Access Compliance Report Public Rights-of-Way (Curb Ramps)

Main Street: DANZA_ST Cross Street: CORAZON_ST Location: W

ADA ID: RPRK211116135507 Ramp Type: Type 4 - Parallel Initial Pass/Fail: Pass Overall Compliance: No Severity Score: 0

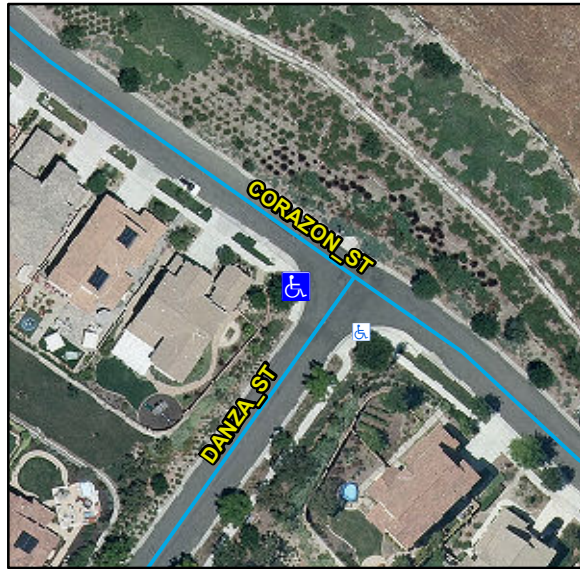
Remove & Replace Landing. Remove & Replace Gutter.

R304.5.3, STD 1115
